Appendix A

Agency and Public Scoping and Review Information

10. Corps of Engineers Letter from Don Getty to USEPA, dated May 8, 2001 and Memorandum For Record by Tim Higgs dated May 8, 2001. Responses to EPA Review Comments on DSEIS.

Enclosure: Drawings 101510-7 and 101510-15, 100% Submittal dated February 2001
Plans for Construction of Vulcan Disposal Area and Haul Road

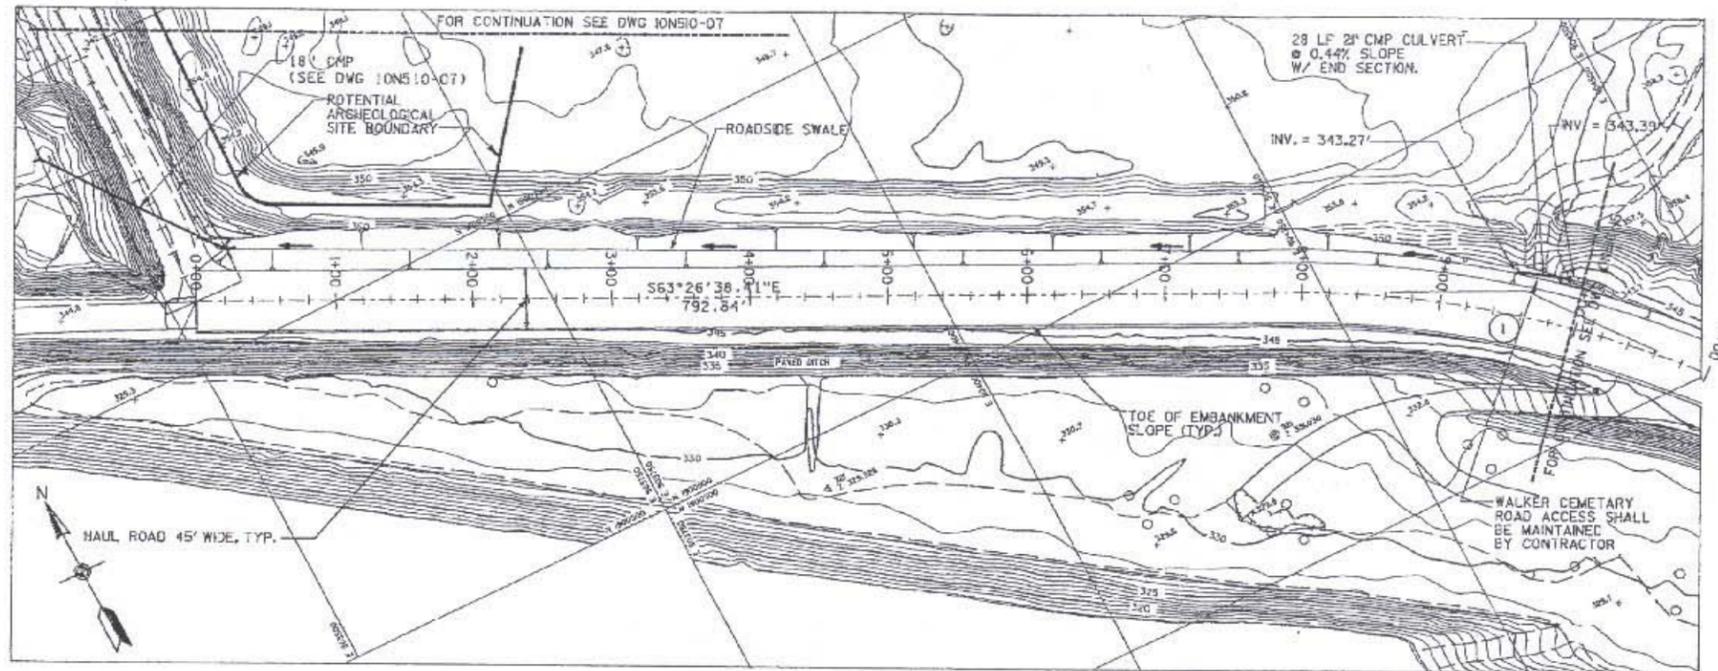
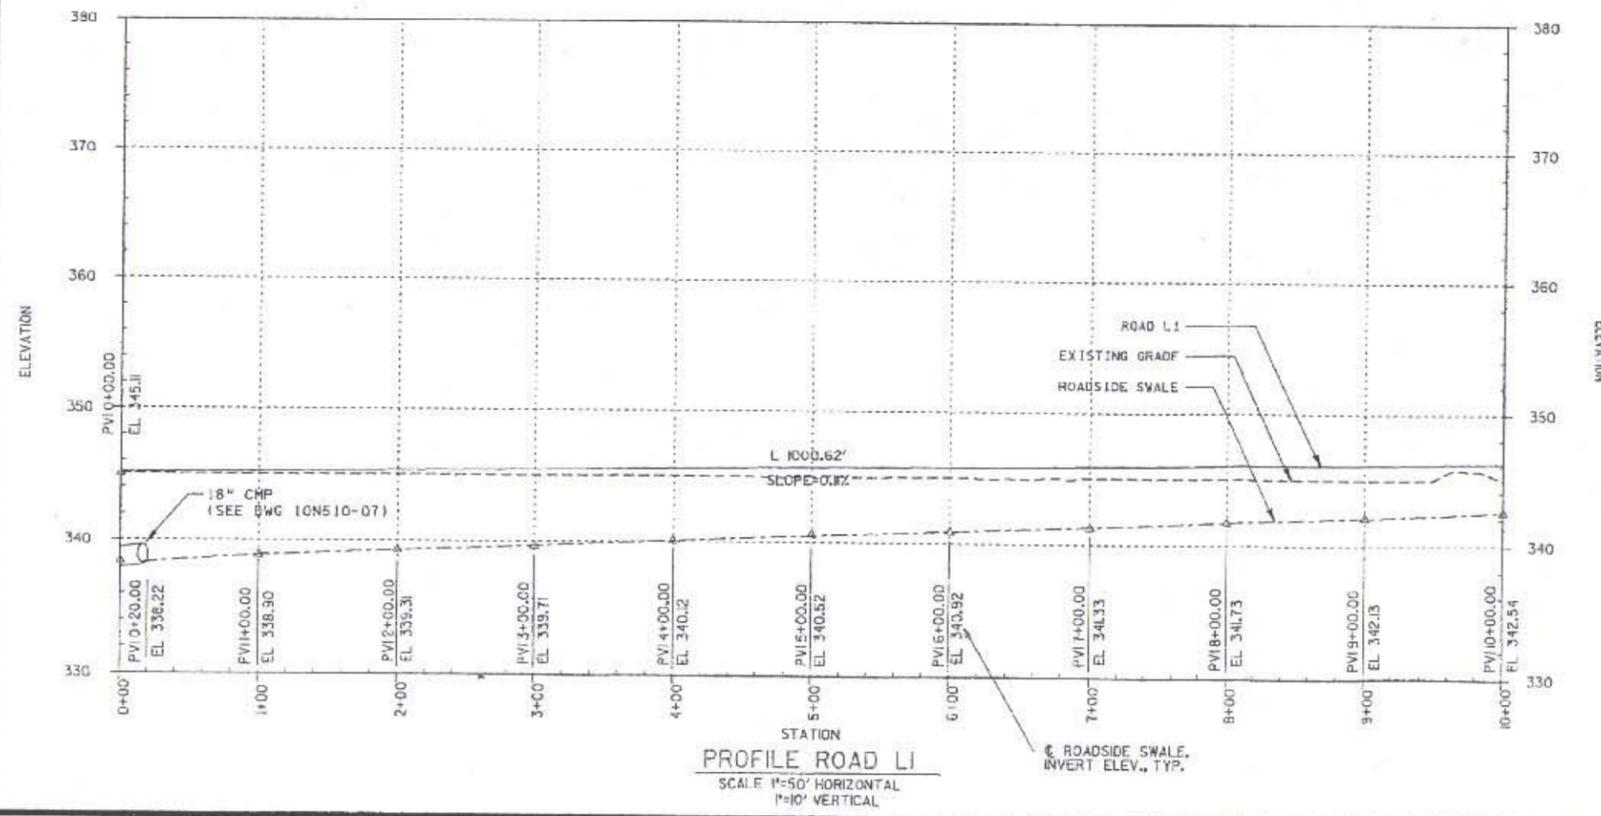
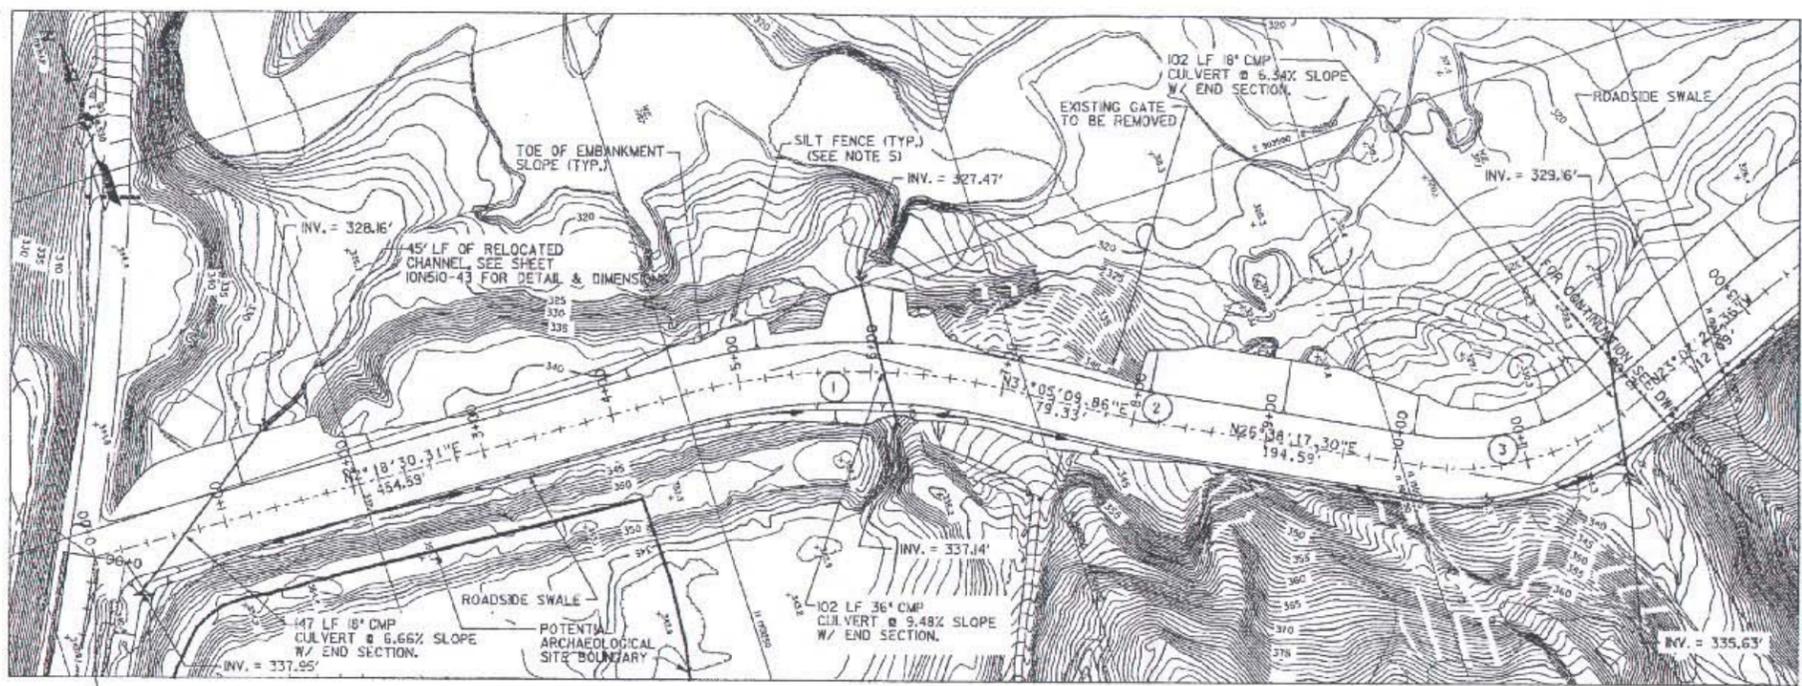
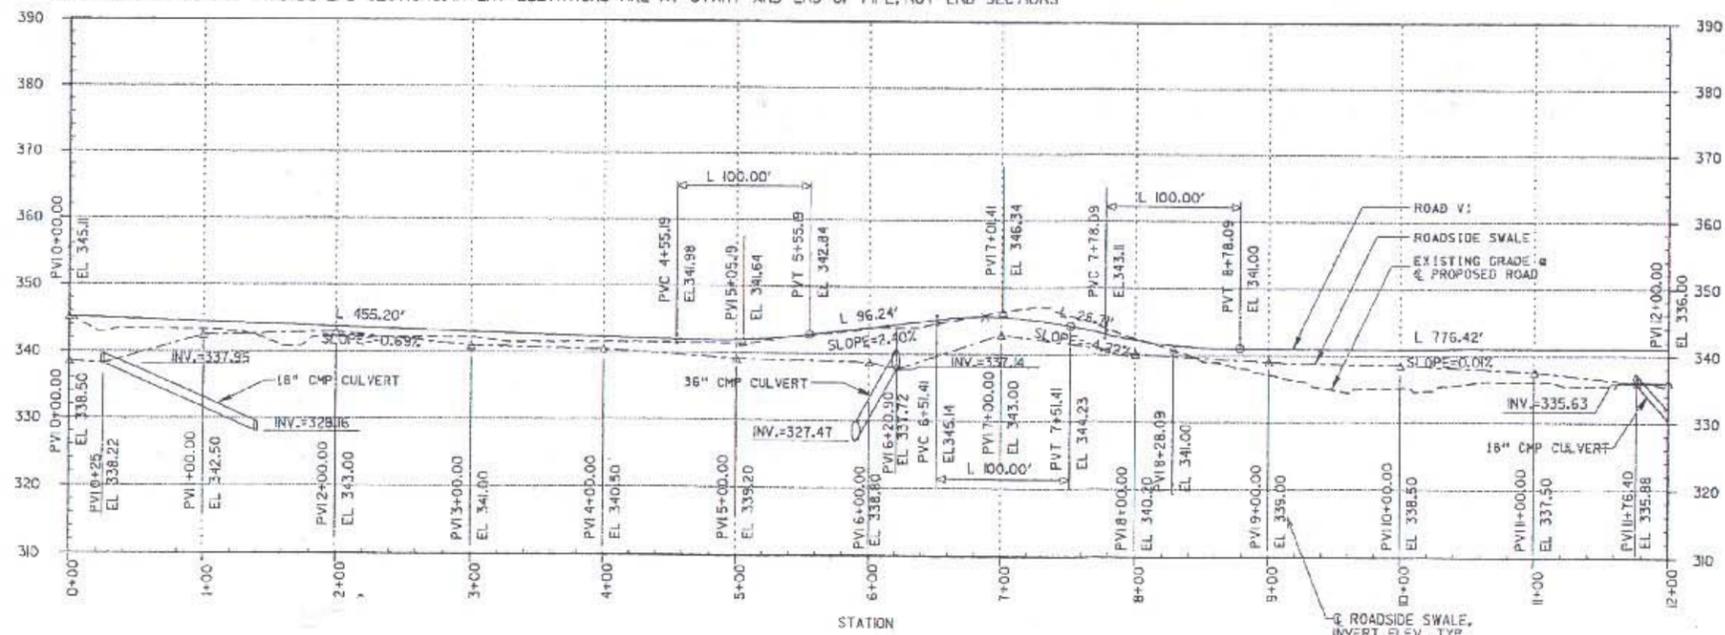
10. Figure 25: We would like to see the road to the Vulcan Disposal Area depicted on the map for reference. Page 28, section 4.13 states the two archeological sites are away from lands affected by the lock project. Adding the road to the figure will graphically show that no impact is likely.

Response: For all practical purposes, the road shown on Figure 25 is identical to the future VDA Haul Road. Attached are two drawings from the plans and specifications for the upcoming haul road construction contract showing the potential archeological sites and the work limits for the haul road. A physical barrier exists between the existing/future widened road and the archeological sites in the form of a containment dike from the original construction of Kentucky Dam. The specifications for the haul road construction require the contractor to avoid any disturbance to the dike. The actual archeological sites are within the former containment area and are now covered by material from the original Kentucky Dam construction. We believe these precautions are adequate to avoid impacts to the sites.
